CONSTRUCTION PLANS
FOR
**CARRIAGE MEADOW SOUTH AT
LORSON RANCH FILING NO. 2**

**EARLY GRADING PLANS
AND DETAILED GRADING PLANS**

PUDSP-19-005

City of Colorado Springs Stormwater Quality

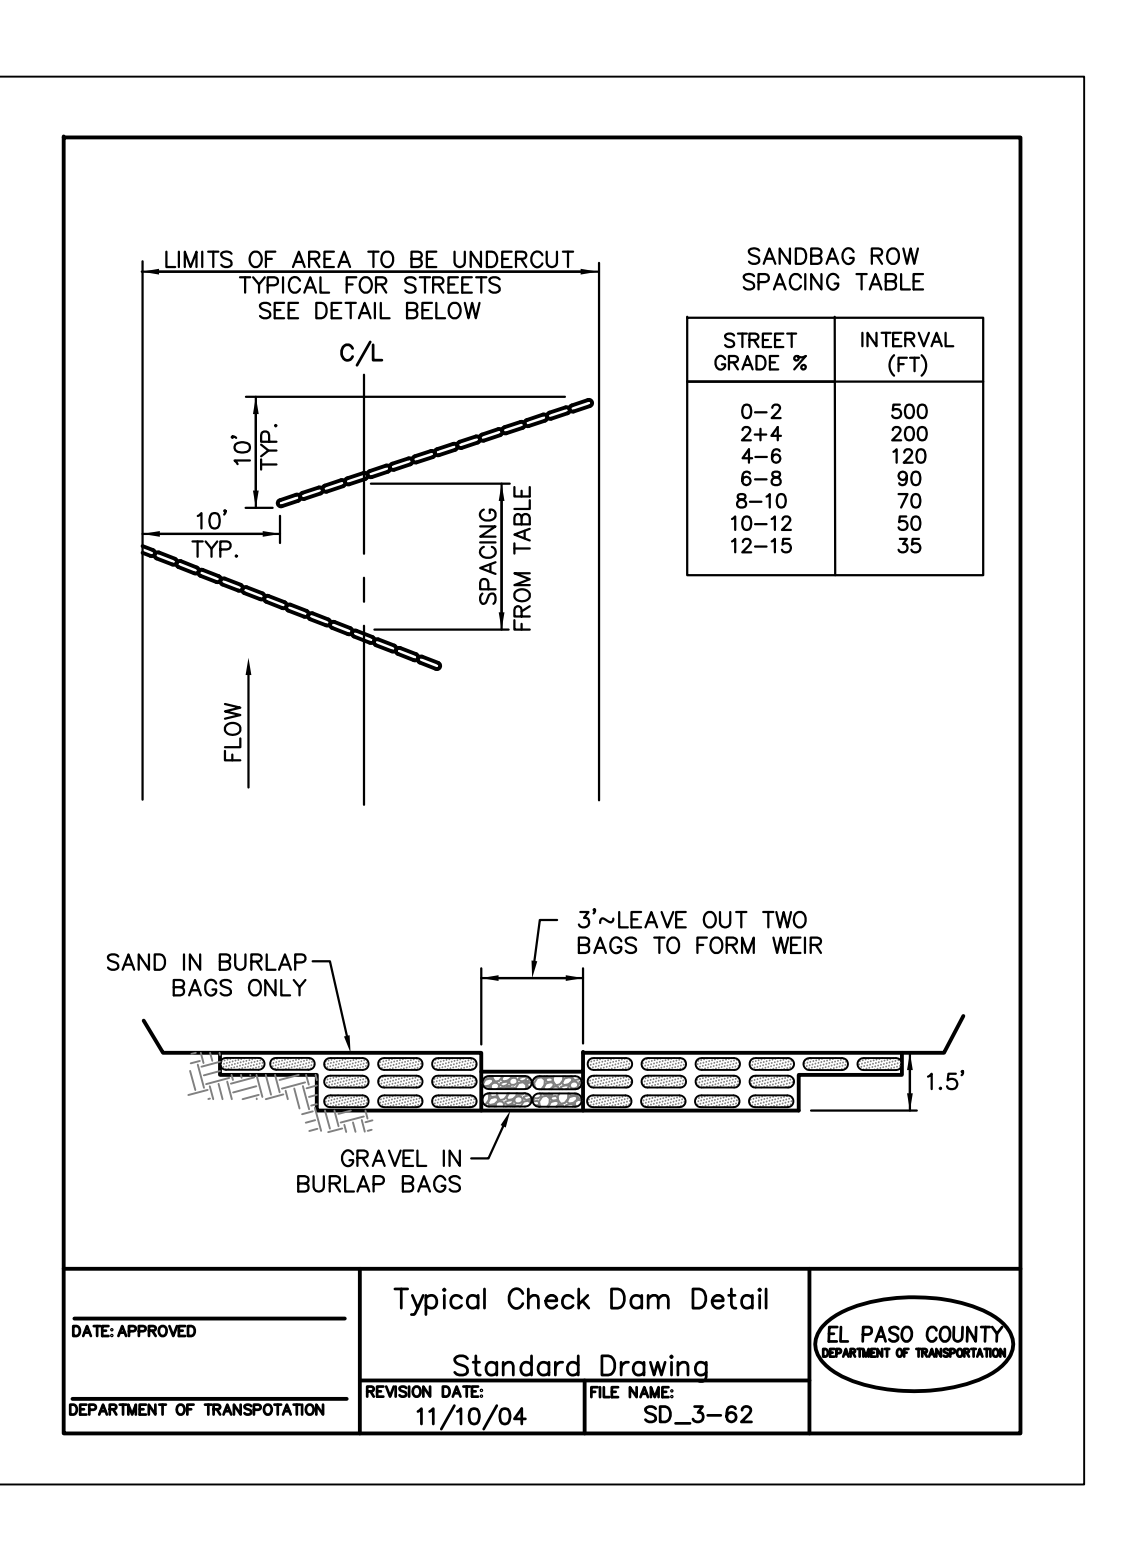
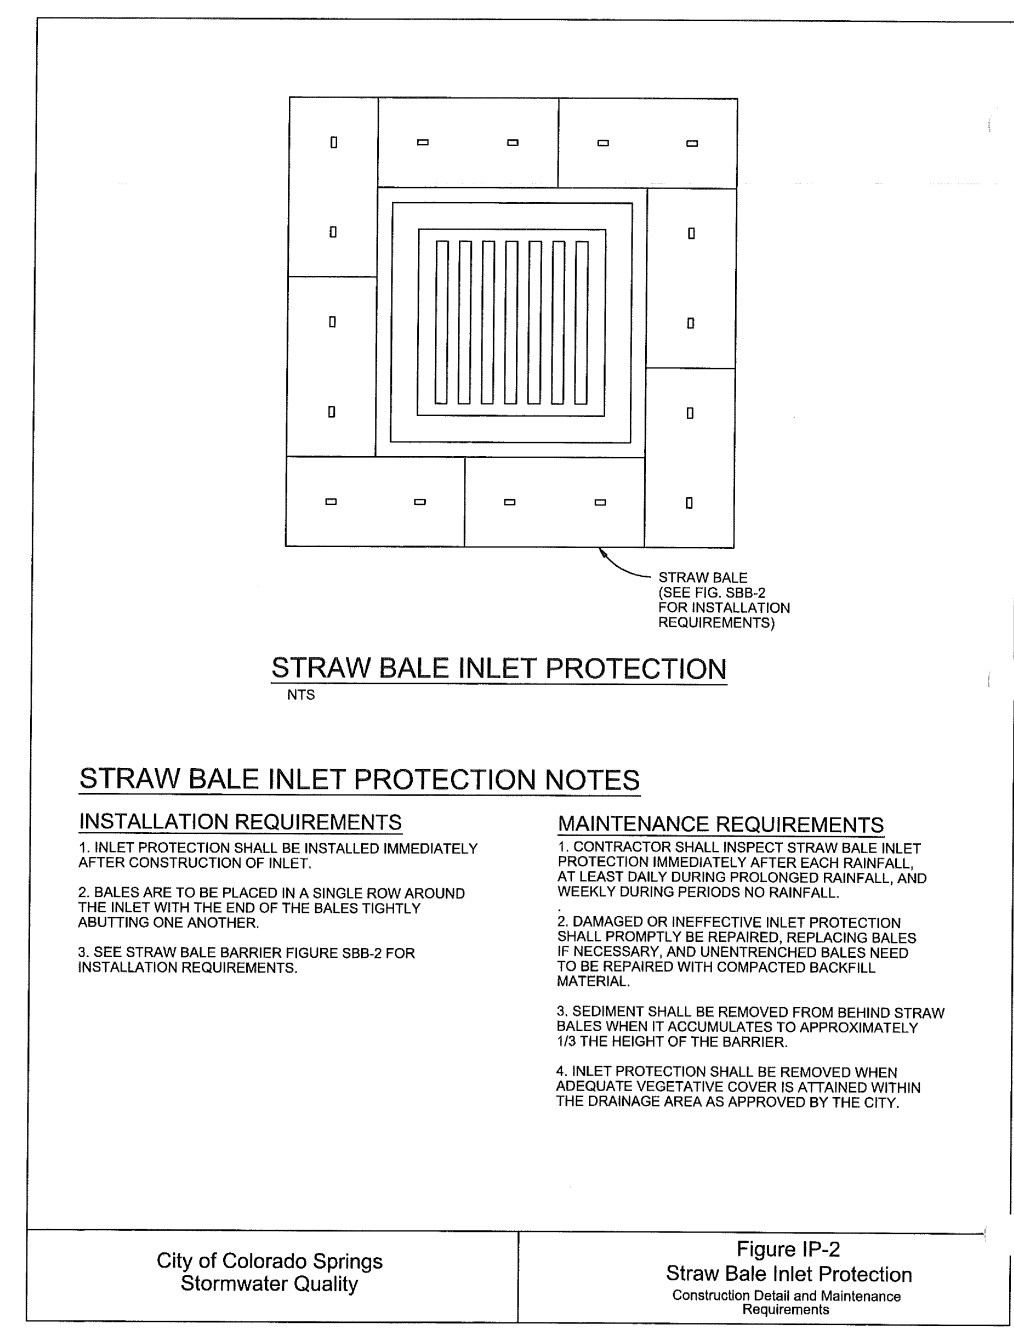
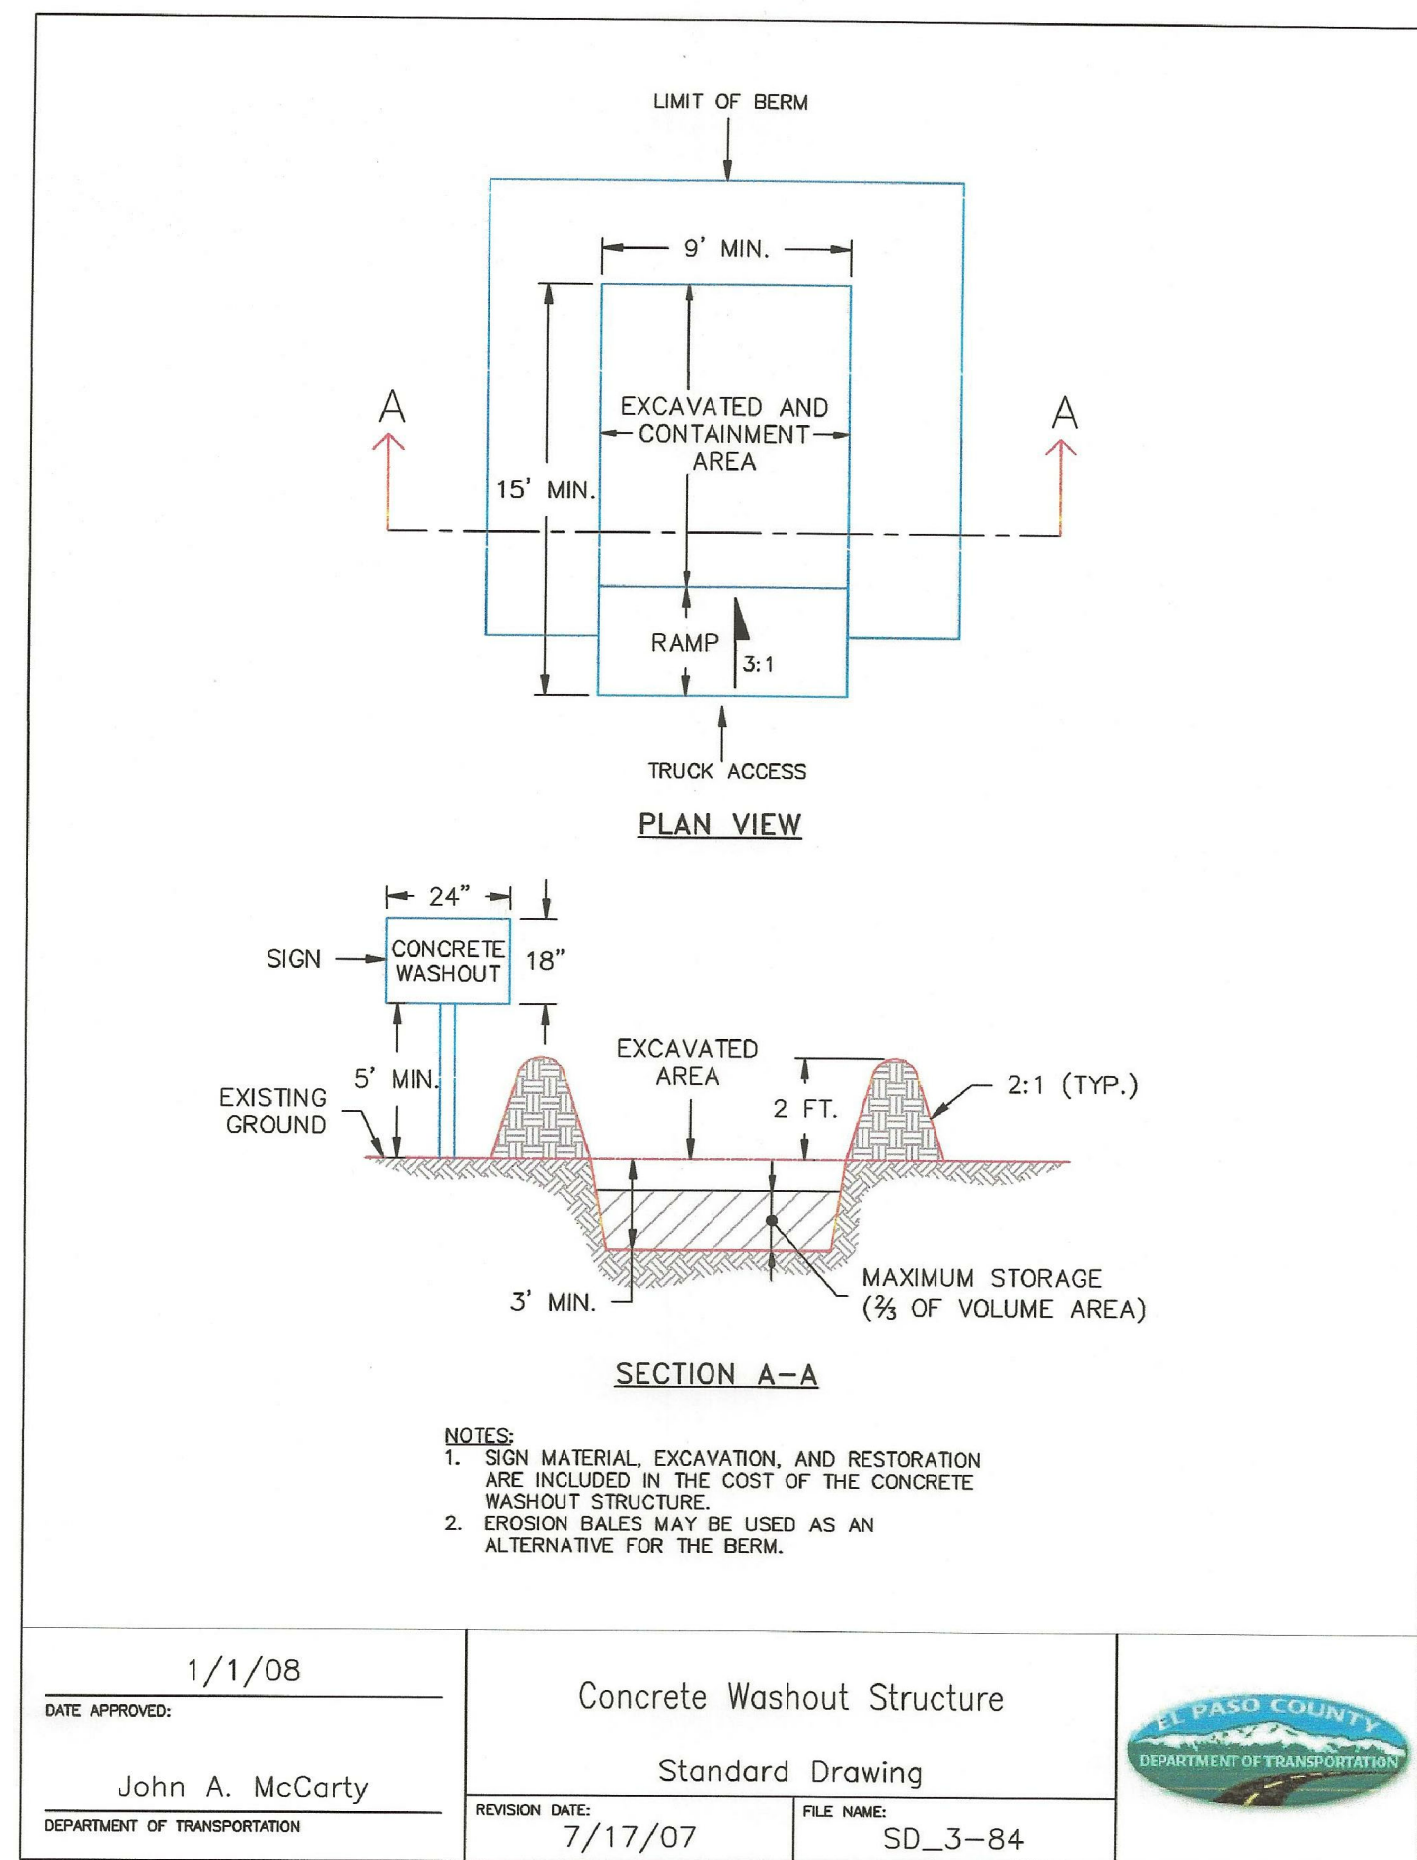
Please expand the size of these 10 details so they cover evenly these two plan sheets. We would like to be able to have the printed out and read on an 11 X 17 paper.
